SGW-58795  
Revision 1

# Monthly Groundwater Meeting March 2015 with Ecology

**216-A-37-1 Discussion Comments:**

Figure 2-3. General Stratigraphy at the Hanford Site

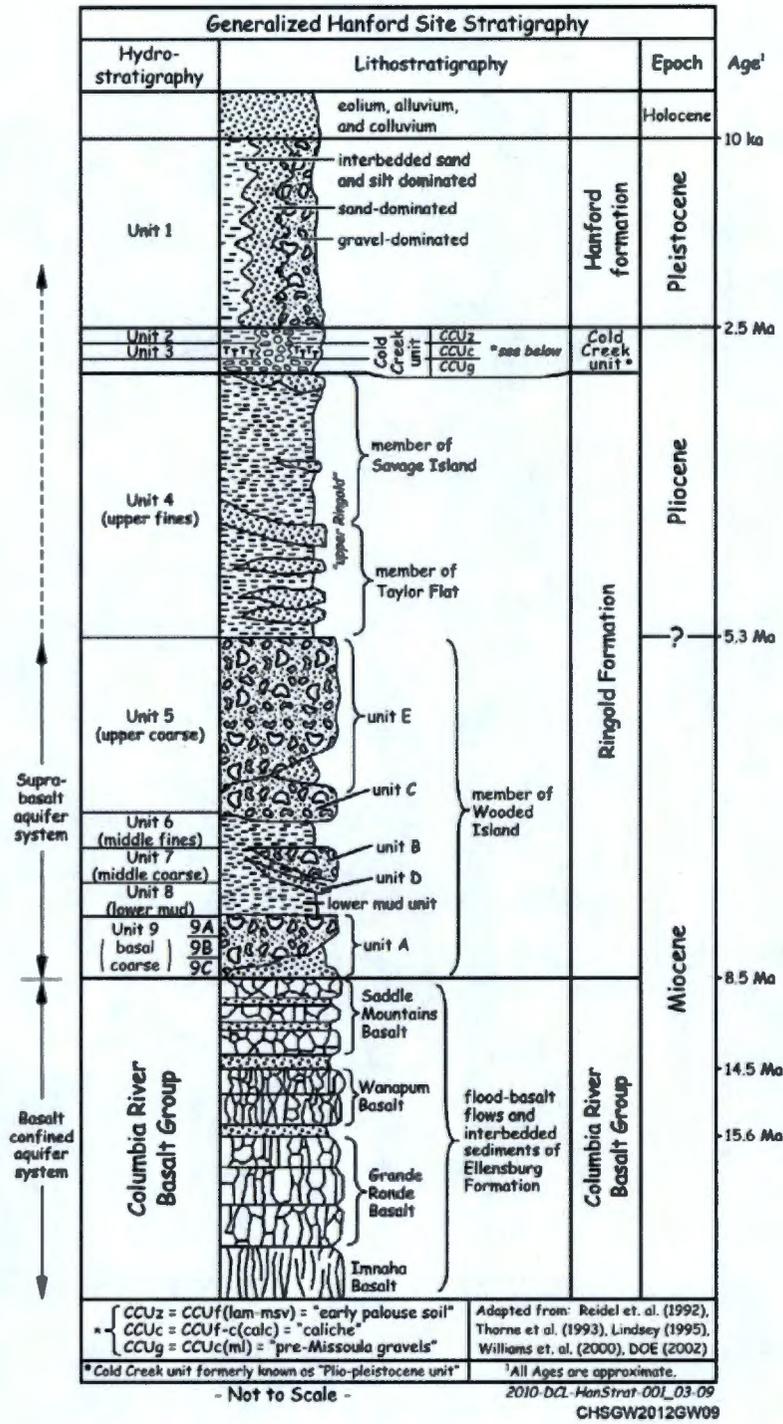
- General: need verbiage consistency throughout figures, maps, etc., e.g., upgradient vs. up gradient. Believe it should be upgradient.
- Slide 4 Figure 2-3: use color to aid in discerning between stratigraphy
- Slide 15 Figure 2-15: Look at 3D from Leapfrog through Intera.
- Slide 17 Table 3-1: Total organic halogen – should this be total organic halides?
- Slide 18 Table 3-2: Add total well depth and elevation with respect to cross-sections. Verify screen bottom for Wells 299-E25-17 and 299-E25-19.

Figure 2-4. Northwest-Southeast Geologic Cross Section Showing the Stratigraphy Below the 216-A-37-1 Crib.

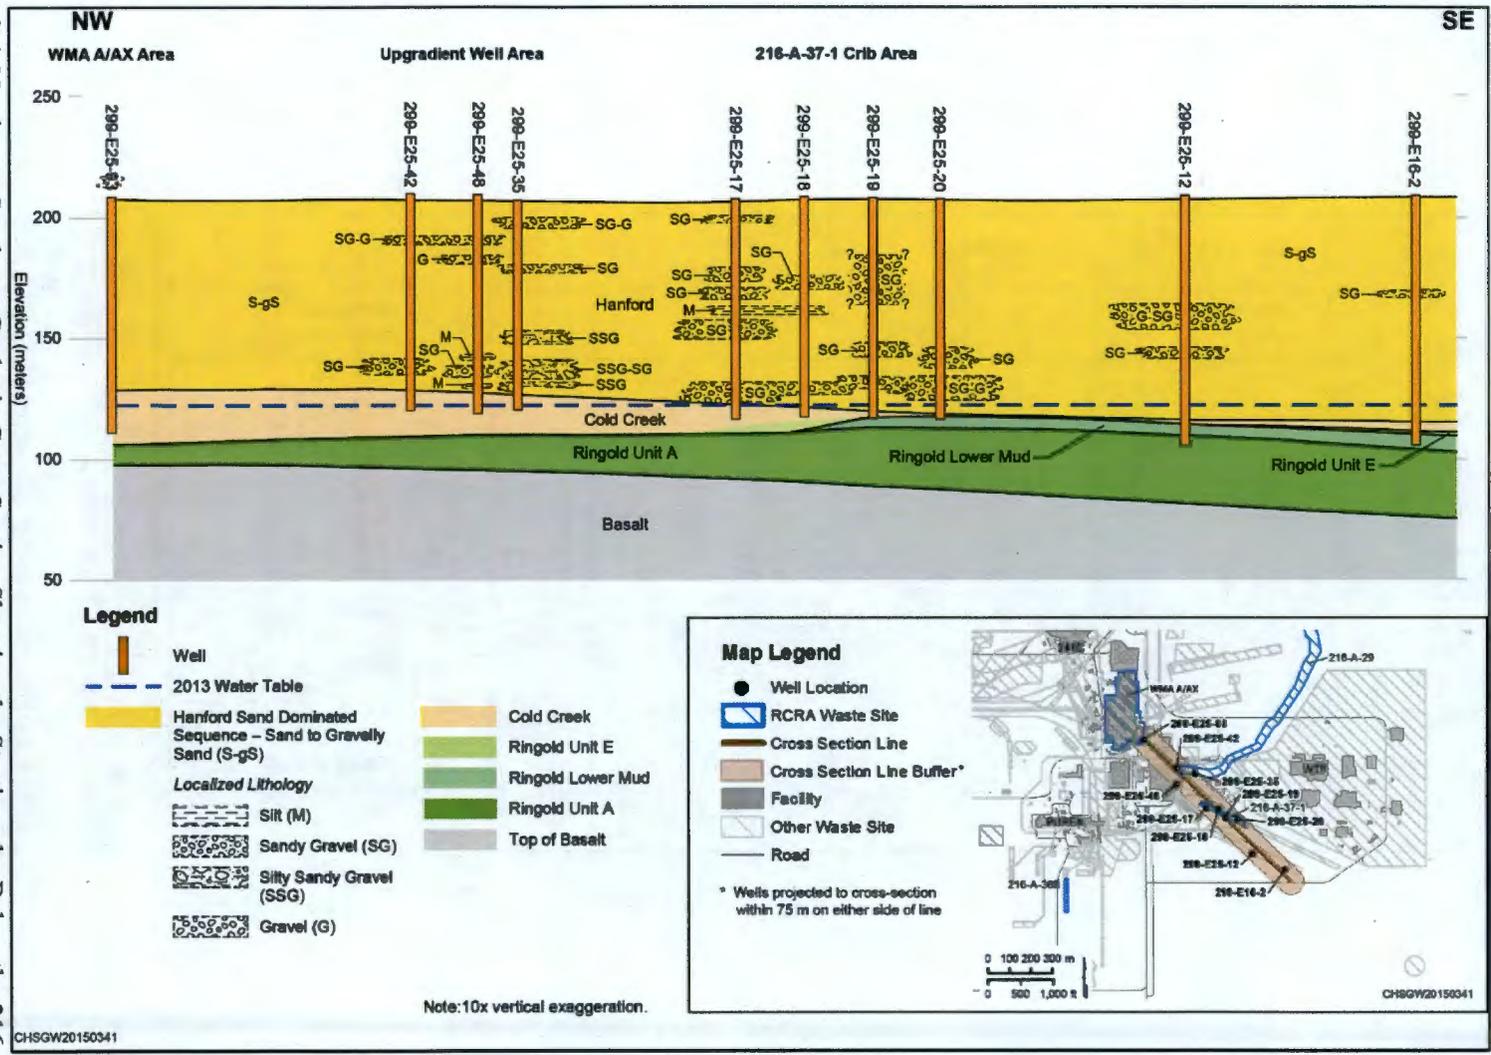
- Suggest we be consistent with WMA-C PA model development as we move to the A/AX farm PA work.
- Figures 2-4, 2-5, 2-6 add wells to basalt to show support for our interpretation and integrate geophysical work as appropriate (i.e., micro seismic, resistivity, TDEM, micro gravity work).

- General comment: likes the analyses presented.
- Slide 5 – Figure 2-4: Drawing water from the cold creek, and wells are close but no gradient displayed. Any changes? No well but new interpretation.
- Slide 7 Figure 2-6: preferential flow path?
- Slide 8 Figure 2-7: low gradient – trend surface analysis?
- Slide 17 Table 3-1: Identify or flag new/proposed well and statement somewhere regarding new critical mean calculation.
